UTTAR PRADESH METRO RAIL CORPORATION LTD.

Sub : Pre-Bid Reply , Addendum-04 and Updated BOQ to Tender Package LKE(02)-01

Ref : Tender no. LKE(02)-01:- "Design, Supply, Installation, Testing & Commissioning of Receiving cum Auxiliary Main Sub Stations Including 750 Volts DC 3rd Rail Traction System, 33kV Cable Network, ASS, TSS & SCADA System for East West Corridor (Phase 1 B) of Lucknow Metro Rail Project at Lucknow, Uttar Pradesh, India"

01 DEPOT CABLE ROUTING

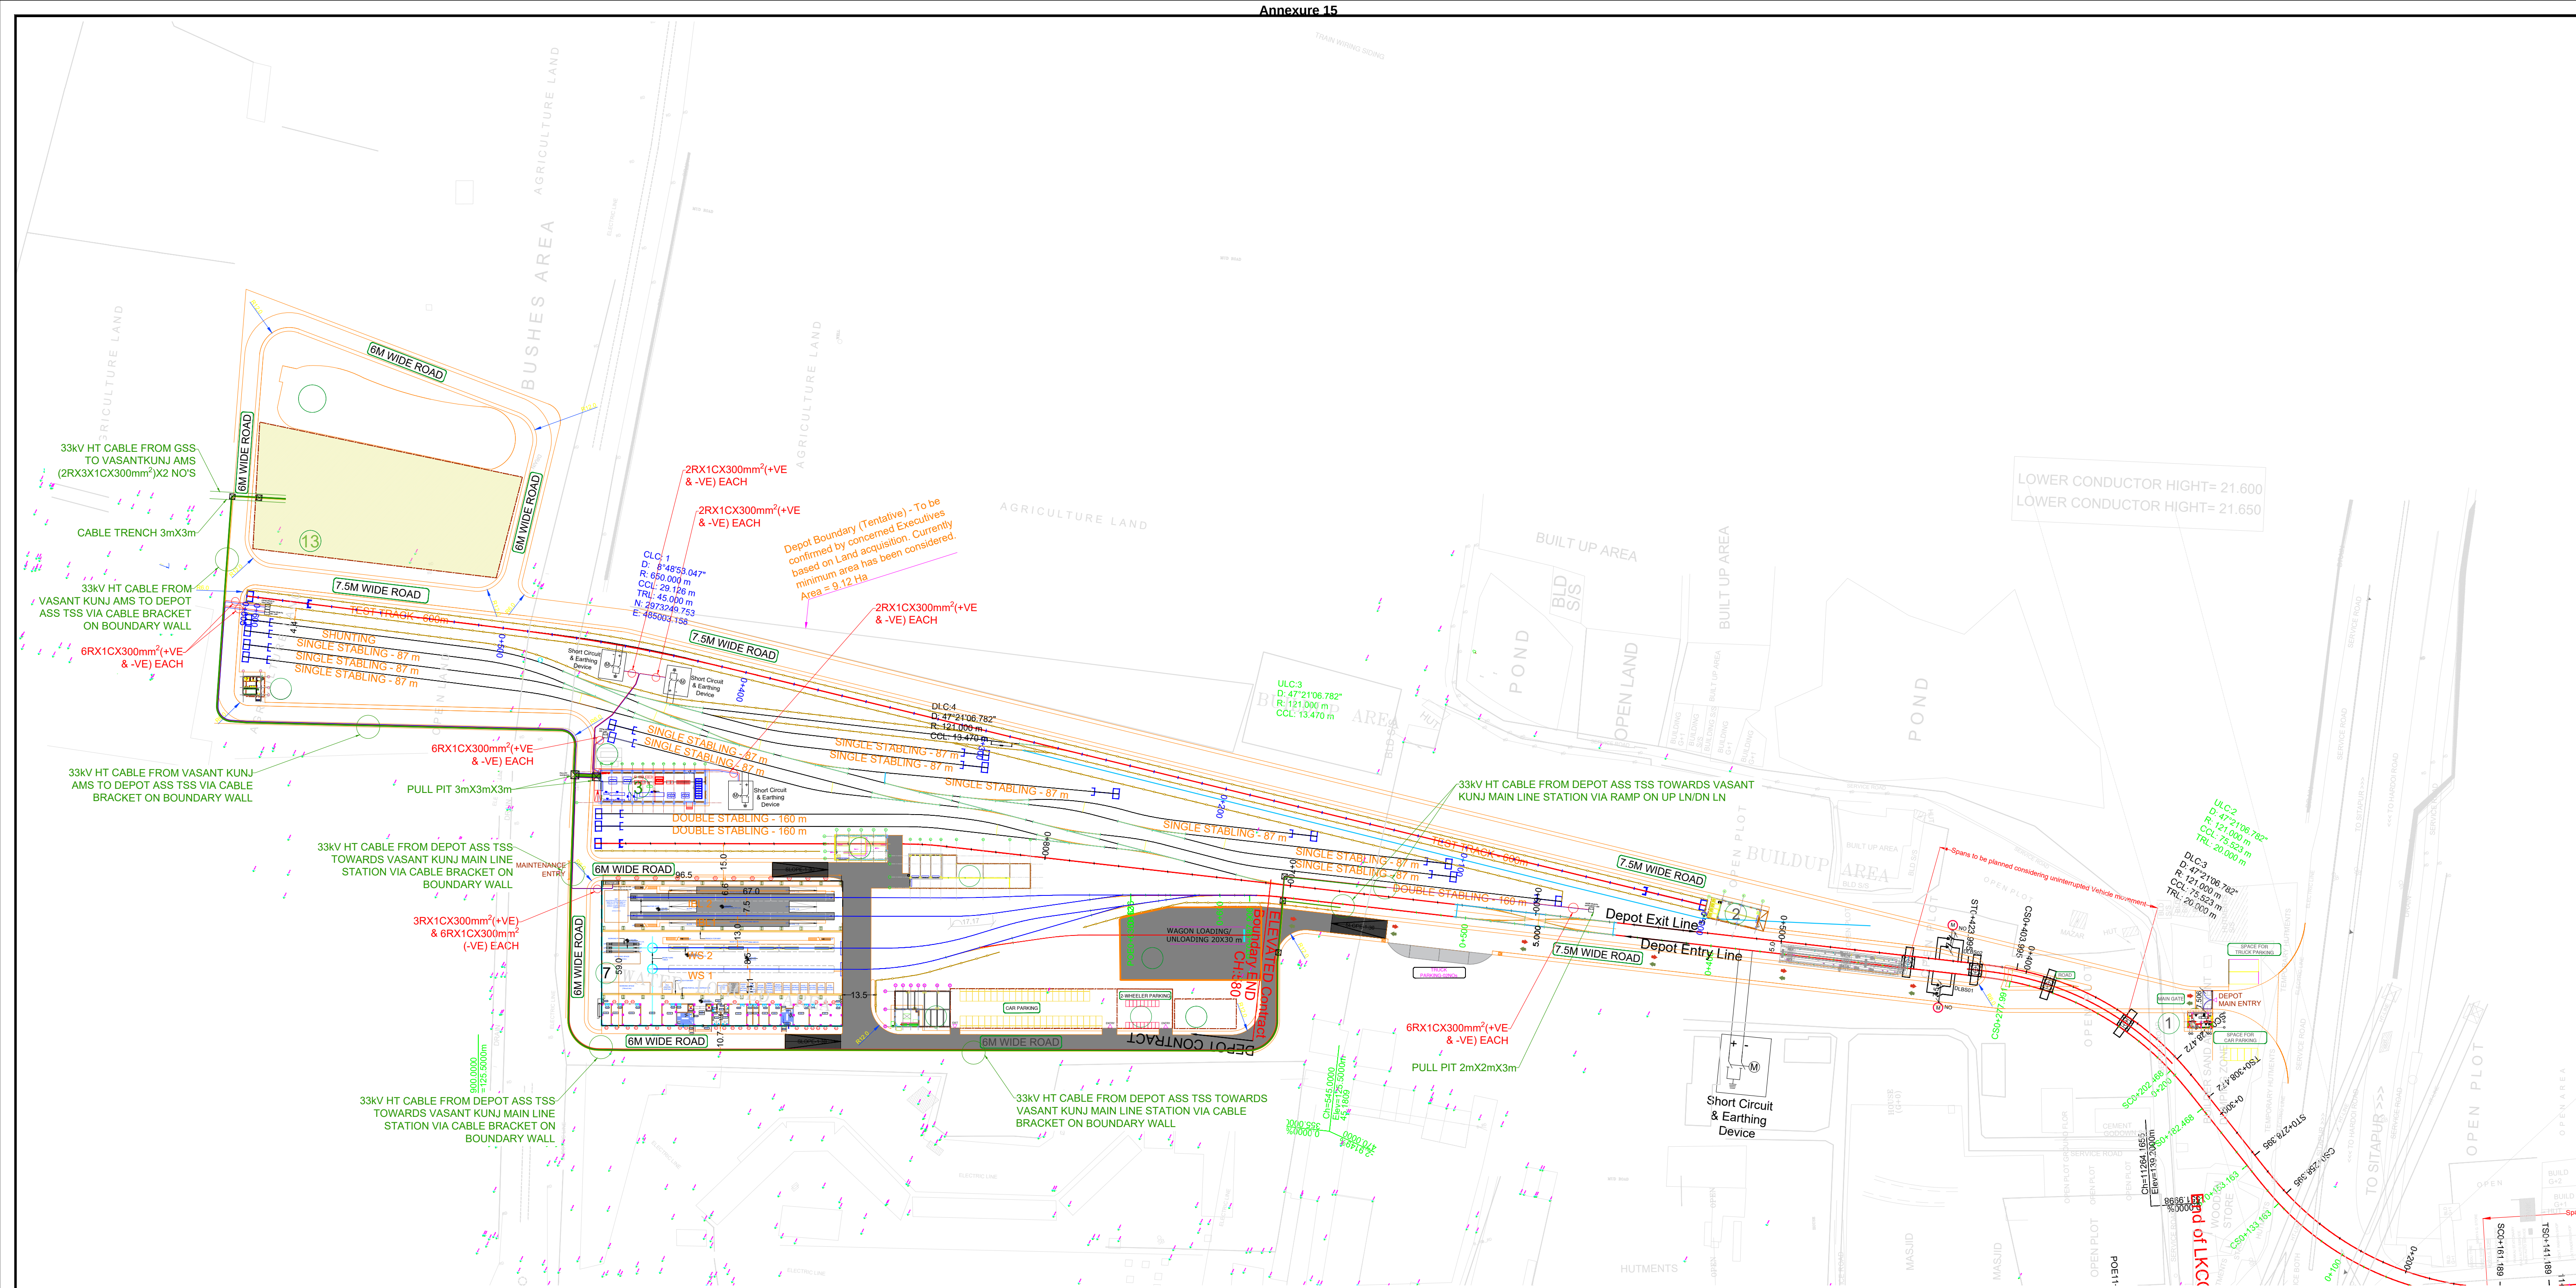
485.	Drawing	Depot Layout (LKO PH_1B/GAD/SHEET-14 OF 14) provided in the Addendum-2.	Please provide the depot cable route from depot TSS to various switches (dis-connectors)	Please refer addendum 4
